CUSTOMER TECHNICAL MEMO # 303

Subject HAWKESBURY MFE3 HD HEAD
TRACK UPGRADE

Date: 4/10/17

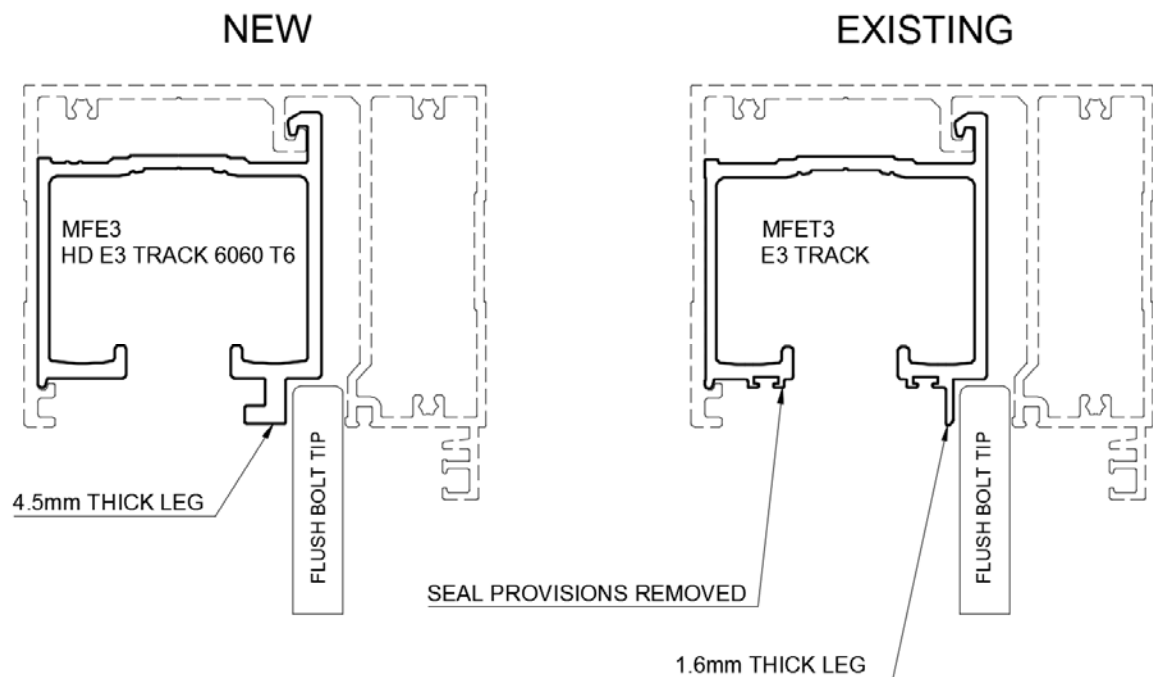
We are pleased to advise that the MFET3 head has been upgraded to eliminate the need to reinforce the thin flush bolt retention leg with a 6mm flat bar as previously detailed in our tech manuals.

The new MFE3 extrusion is now offered in T6 temper as standard and the flush bolt retention leg has been increased from 1.6mm to 4.5mm. The unused brush seal provisions have also been deleted for a cleaner look.
